Informations techniques / Technical Matters

SUBJECT: BOSCH STARTERS FOR BSE ENGINES.

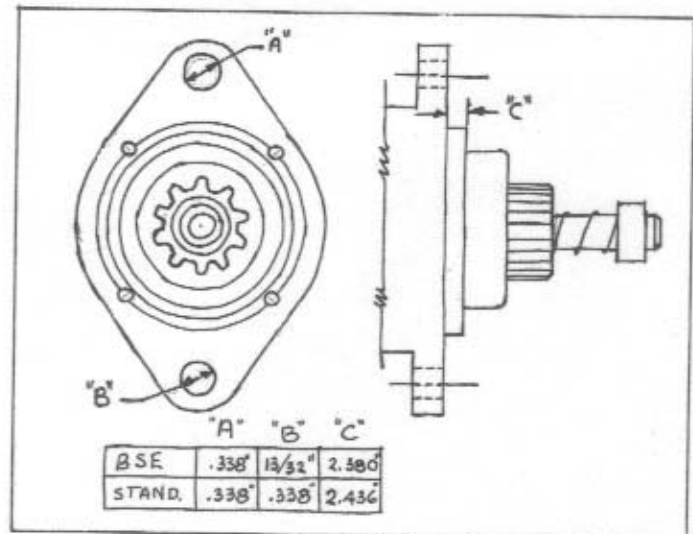
A modification is required to install standard Bosch starters on BSE engines. Refer to attached sketch.

- a) The shoulder of the main body of the starter must be machined to 2.380" (original is 2.436").
- b) The mounting hole at the bottom must be redrilled to 13/32" in lieu of .338".

In view of this modification, a starter installed on a BSE engine is not replaceable by a standard Bosch starter.
